# City of Tualatin

## PARTITION REVIEW FINDINGS AND DECISION FOR PAR 16-0001, BURCHILL

SHEET  
**P500**  
JOB NO.  
2312-020

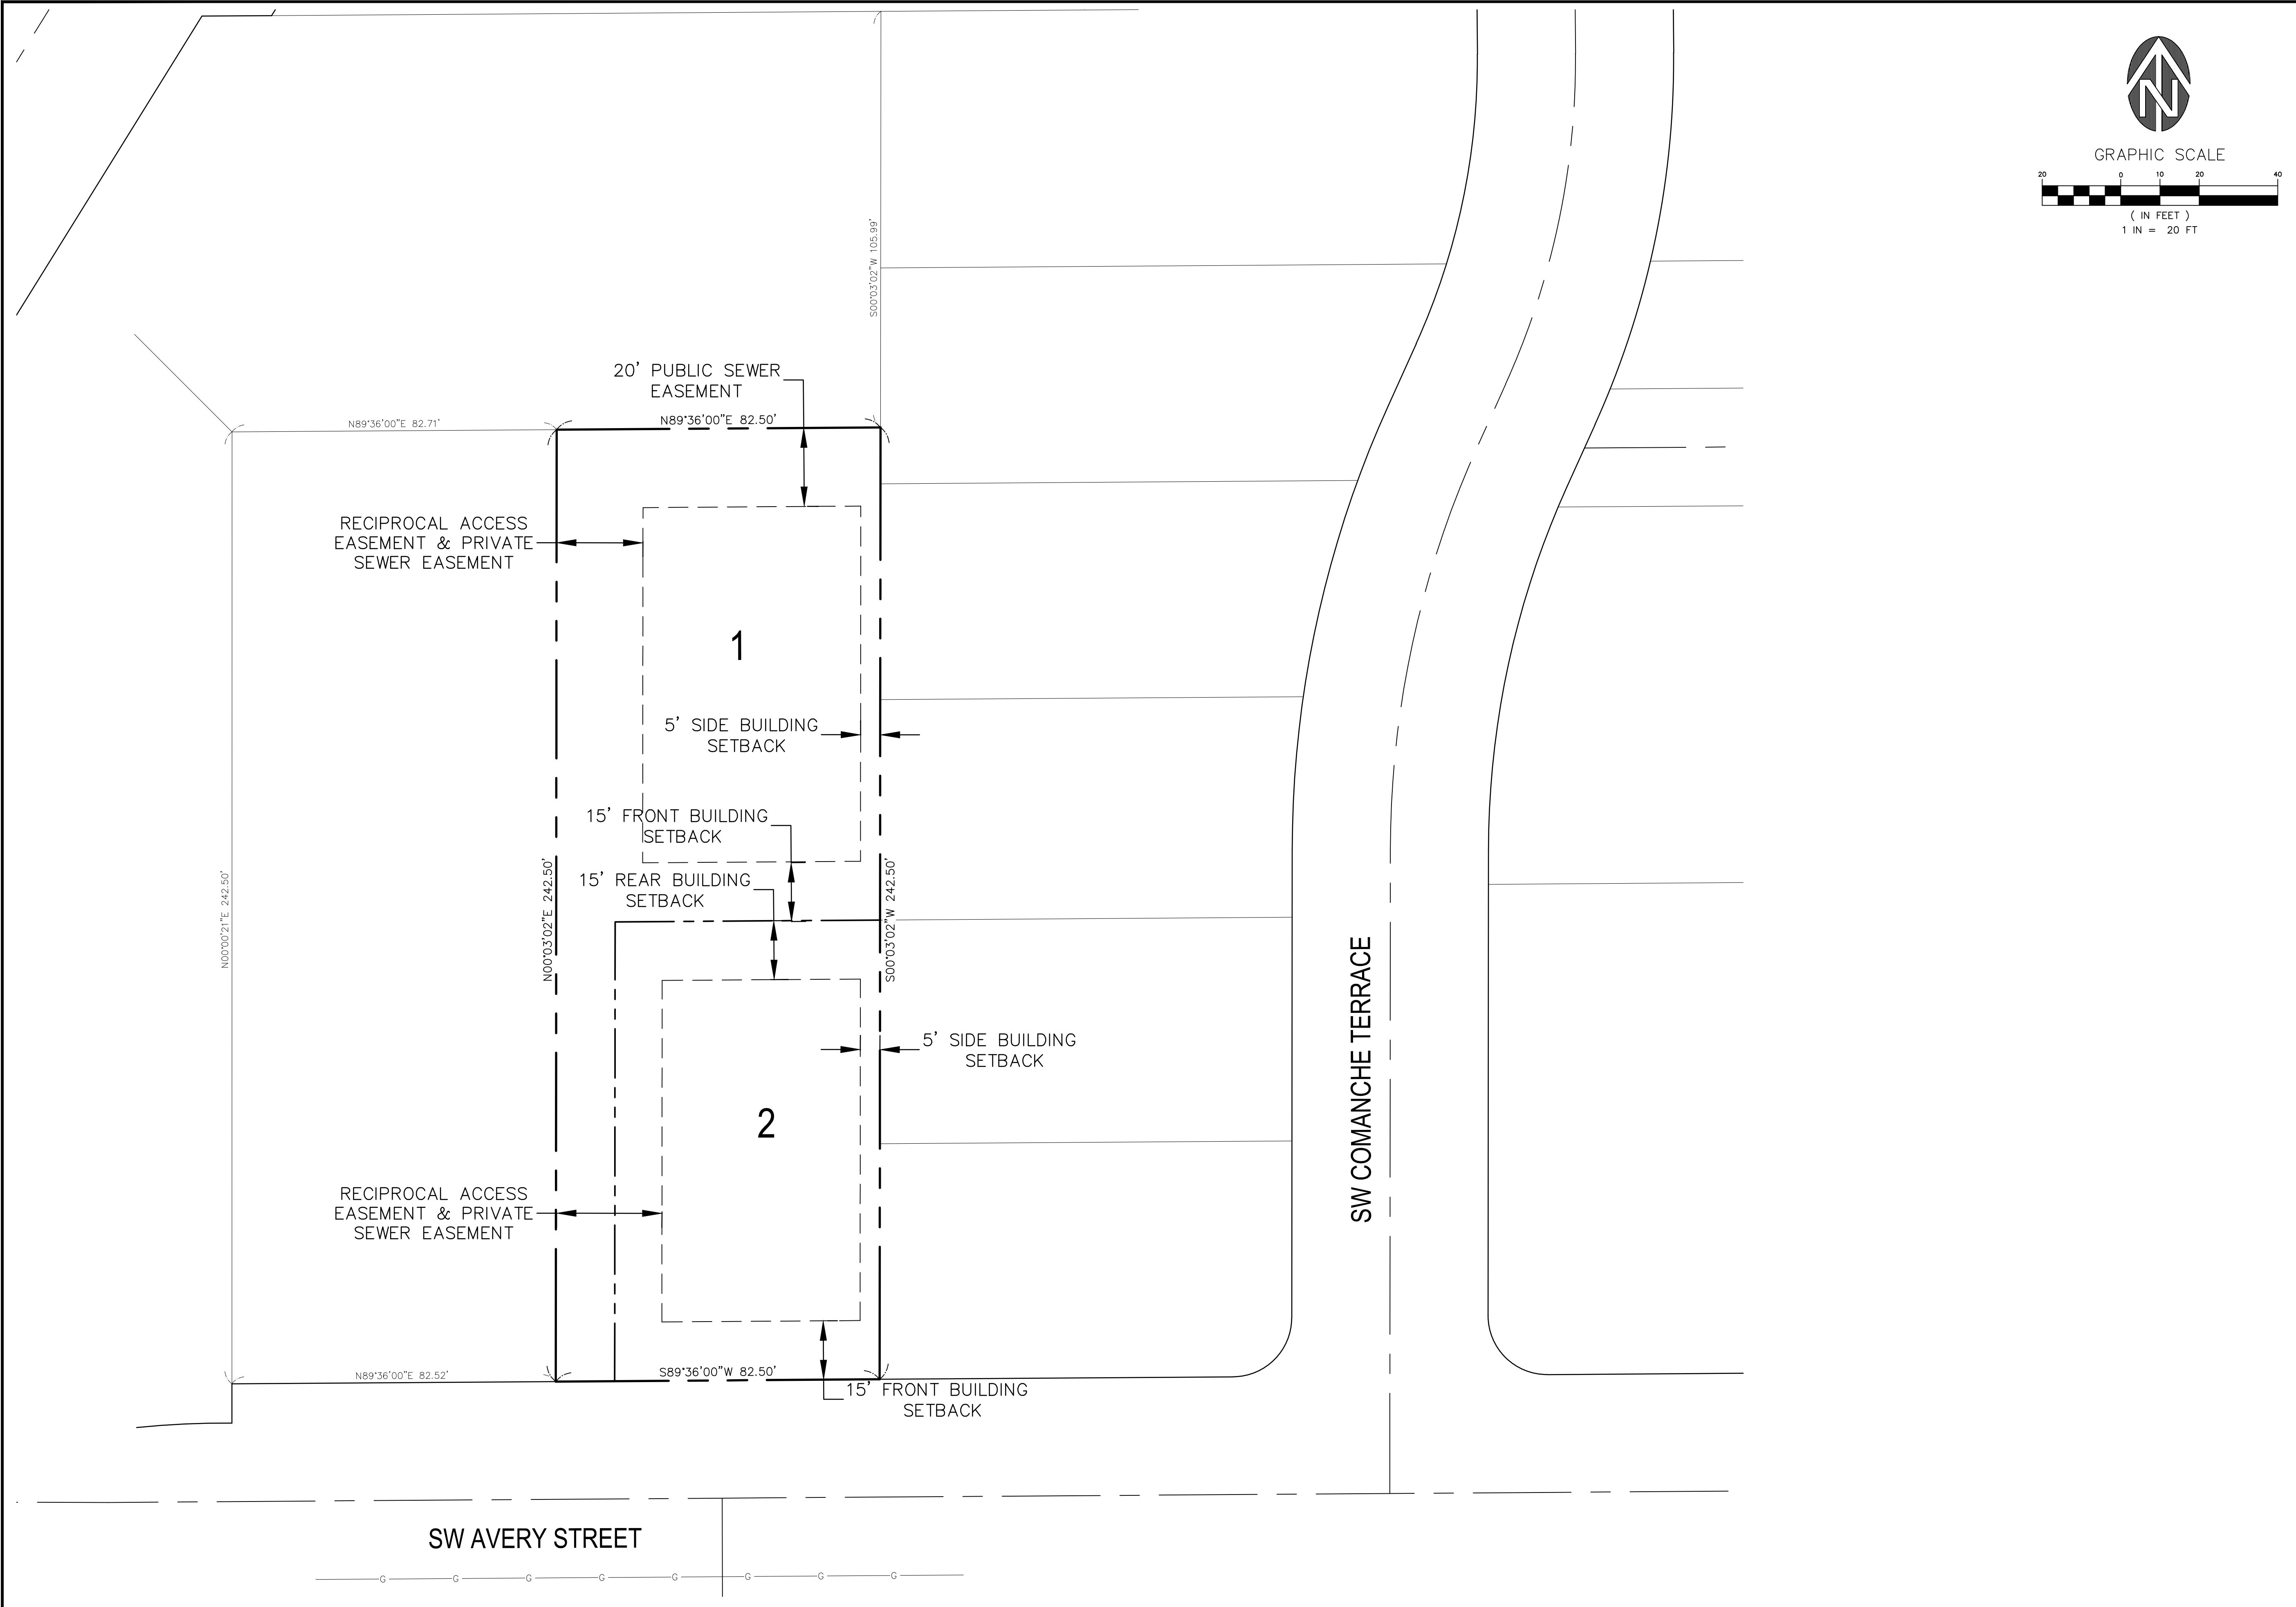
Staff notes a building envelope plan was submitted as sheet P500. The plan demonstrates correct front yard, side yard, and rear yard setbacks. Staff notes setback requirements will be reviewed for compliance when a Single Family Architectural Review application is submitted for future dwelling units on Lots 1 and 2.

**PRELIMINARY UTILITY PLAN**

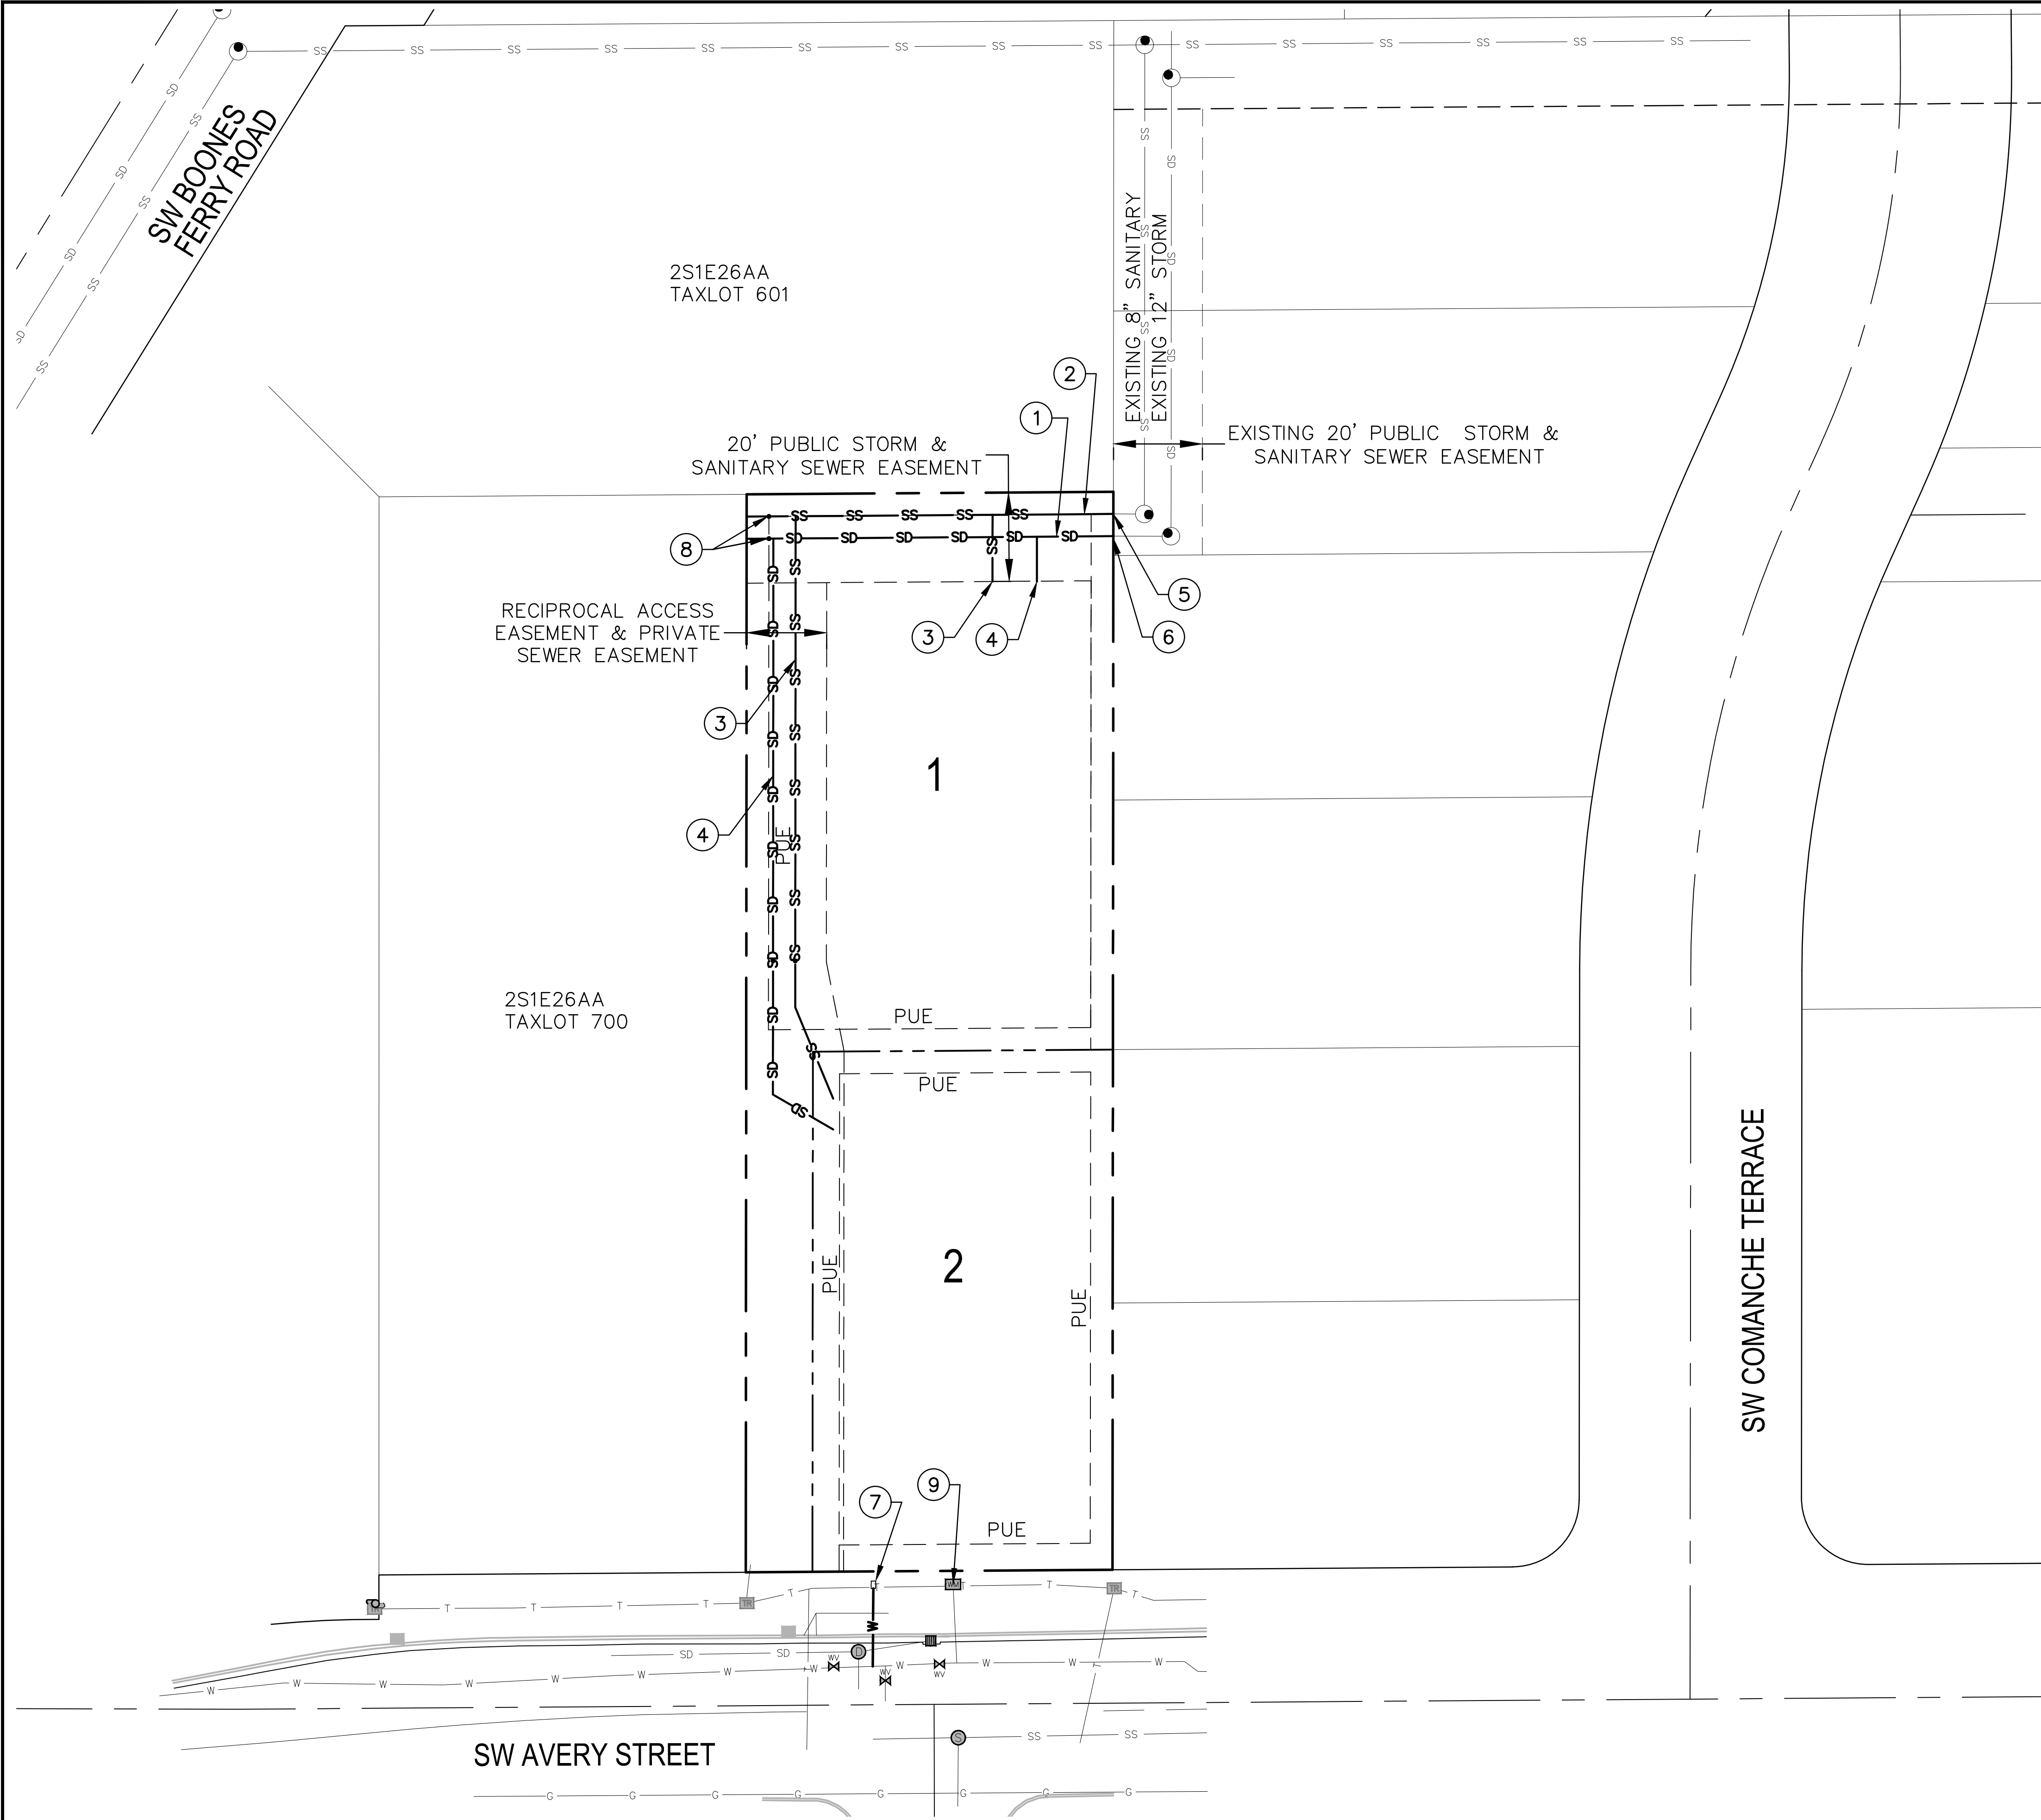
The Applicant has submitted a Utility Plan drawing (See Sheet P600 in Exhibit B) showing how storm drainage lines will be installed to serve the proposed lots. Detailed plans will be submitted for review and approval prior to construction. The applicant will construct LIDA facilities for the 2 lots for treatment. The systems will be connected to the new stormwater main extension at the north end of Lot 1 as shown on the utilities plan.
